Final response to reviewer comments on HESS 2021-543, The Mesoamerican mid-summer drought: the impact of its definition on occurrences and recent changes.

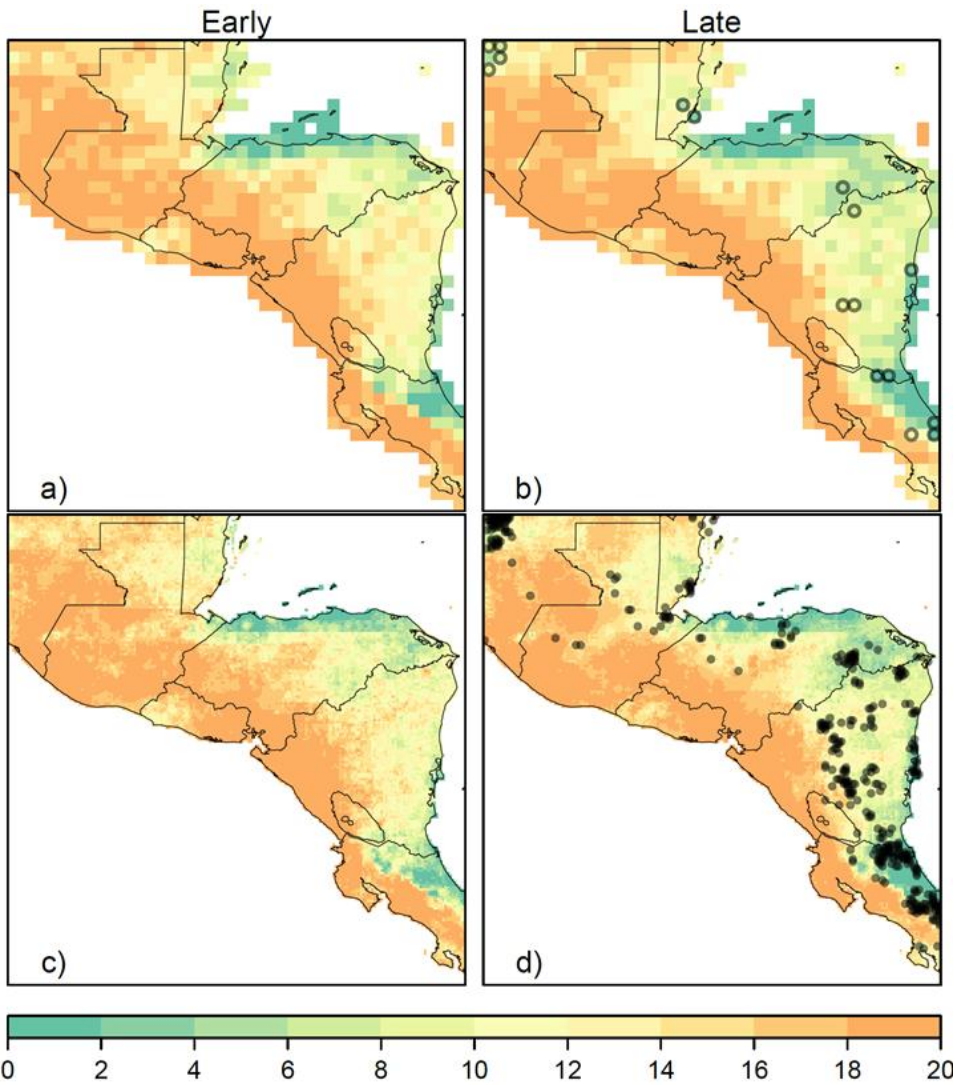
Line 89: I understand that the CHIRPS data was aggregated in the previous study referenced in this sentence (Stewart et al. 2021) for comparison against other precipitation datasets. Please provide a reason for why the data was aggregated in this study since no comparisons against other precipitation datasets are made. I also ask that the authors address how this resampling may affect the characterizations of the MSD.

Thank you for pointing out this shortcoming. We have added to that paragraph the following “The data were aggregated to reduce data volumes and facilitate exploration of the influence of different MSD definitions. To verify that this aggregation does not affect the results of this analysis, Fig. A1 and Table A1 show results for a reduced area in Central America using data at both the original CHIRPS resolution and the aggregated resolution, with consistent results at both scales.”

The referenced Figure A1 and Table A1 are added to the Appendix, consisting of the following:
